**1ST STREET WATER MAIN REPLACEMENT
FROM LIBERTY ST TO CHESTNUT ST
WILTON, IOWA**

ADDENDUM NO.2

June 14, 2023

2 CASING PIPE DETAIL
SCALE: NONE

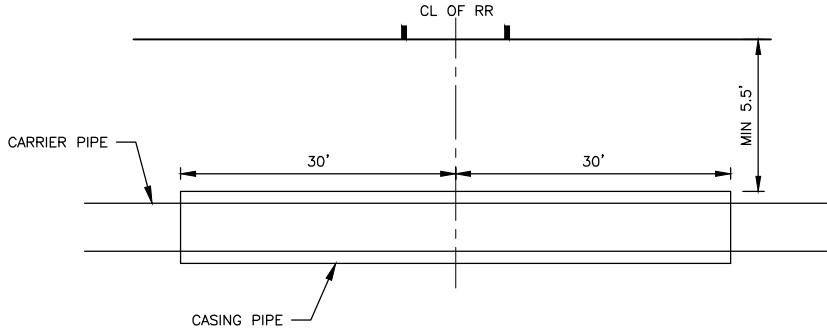
1. **REFER TO SECTION 00200 – INSTRUCTIONS TO BIDDERS**
 - a. **CHANGE** the diameter of the casing pipe in Bid Item 2 diameter from “18” to “14”.
2. **REFER TO SECTION 00400 – BID FORM**
 - a. **REPLACE** the Bid Form with the attached.

A. SUDAS SECTION 3020 FOR TRENCHLESS CONSTRUCTION SHALL BE FOLLOWED. B. THIS ITEM SHALL INCLUDE BUT IS NOT LIMITED TO THE FOLLOWING: RESTRAINED JOINT C900 PVC CARRIER PIPE, 14" STEEL CASING PIPE WITH MINIMUM WALL THICKNESS OF 3/8", CASING SPACERS WITH A MAXIMUM OF 6' SPACING, CASING END SEAL AND TRENCHLESS INSTALLATION.	1
	3	5010-C-1	WATER MAIN FITTINGS, BEND, 6" DI MJ, 90 DEG
